UNITED STATES PATENT AND TRADEMARK OFFICE

APPLICATION NO.	FILING DATE	FIRST NAMED INVENTOR	ATTORNEY DOCKET NO.	CONFIRMATION NO.
10/092,774	03/05/2002	Gary Sprague	27458-1/P11	8633

Office Action Summary

DETAILED ACTION

FIG. 4

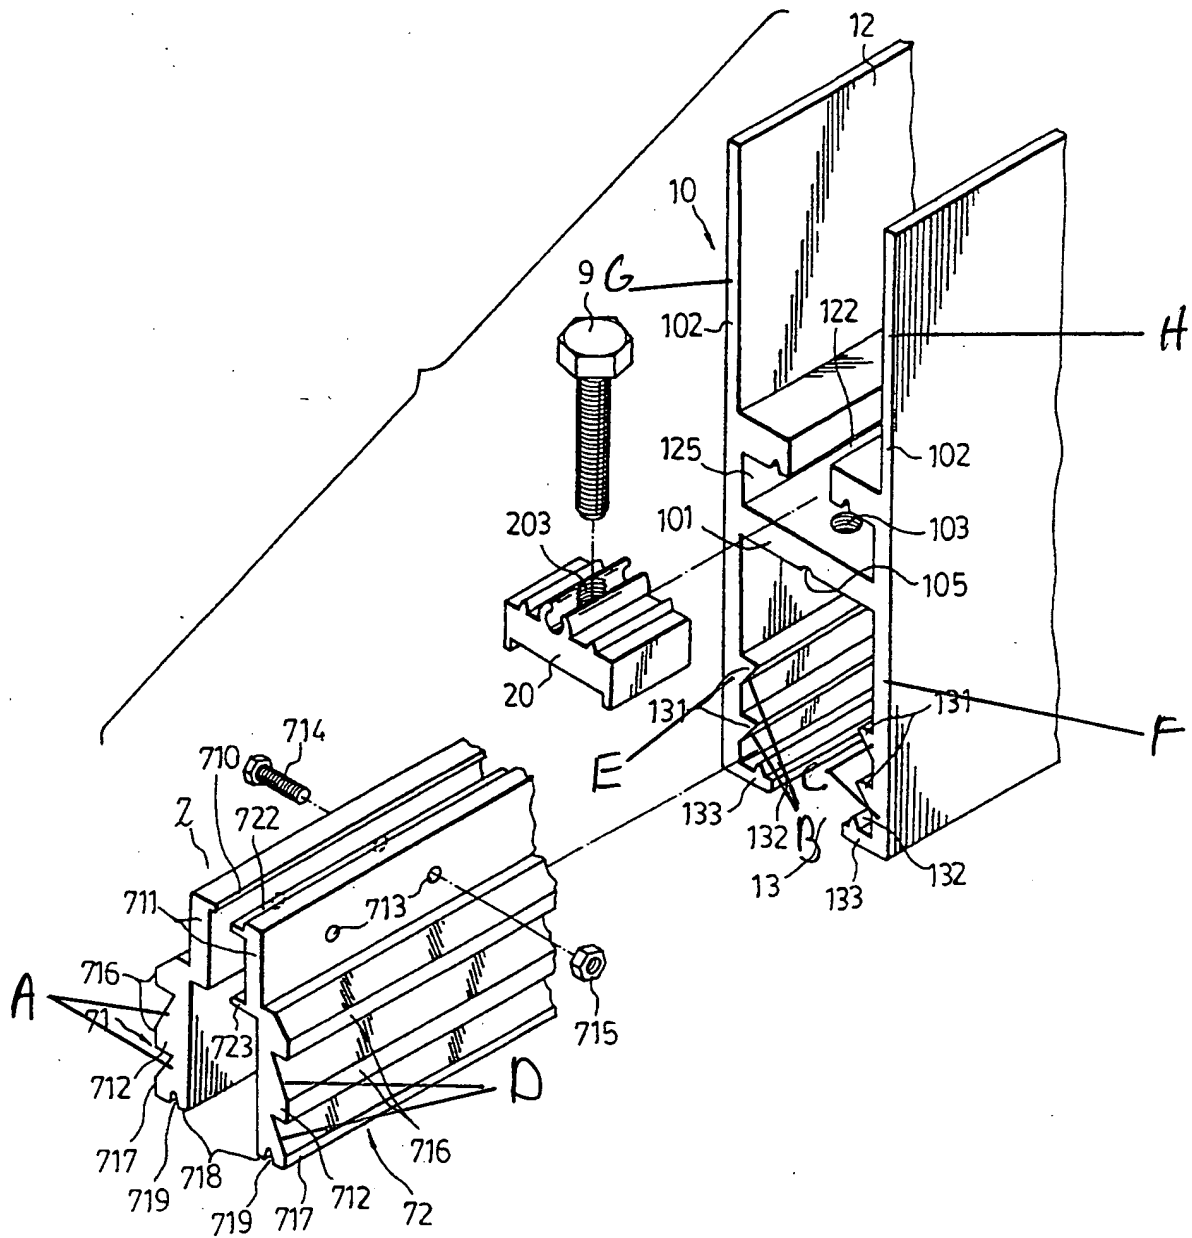
Refer to Fig. 4.

Regarding claim 1, Lu teaches a housing (10) with at least one mating surface (131).

Lu teaches a pair of mating clamp members (71, 72) shaped and structured to clamp onto the panel (1) such that the pair of clamp members (71, 72) respectively constrain opposing major surfaces of the panel (1), with at least one clamp member (71) of the pair of clamp members (71, 72) having a mating surface (A) located to be in contact with the at least one mating surface (B) of the housing (10). (Fig. 4)

Lu teaches actuation hardware (714, 715).

Lu shows the mating surface (B) of the housing (10) and the mating surface (A) of the clamp member (71, 72) is inclined relative to the driven direction. (Fig. 7, 4)

Regarding claim 2, Lu shows an accessory channel space (12). (Fig. 4)

Regarding claim 3, Lu shows the housing is unitary. (Fig. 4)

Regarding claim 4, Lu teaches the actuation hardware is a screw (714) and a nut (715). (Fig. 4)

Regarding claim 6, Lu shows a first (G) and second (H) channel wall. (Fig. 4)

Regarding claim 8, Lu shows the hardware being located at least substantially in the accessory channel space. (Fig. 4)

Regarding claim 18, Lu shows the screw oriented substantially parallel to the first plane. (Fig. 4)
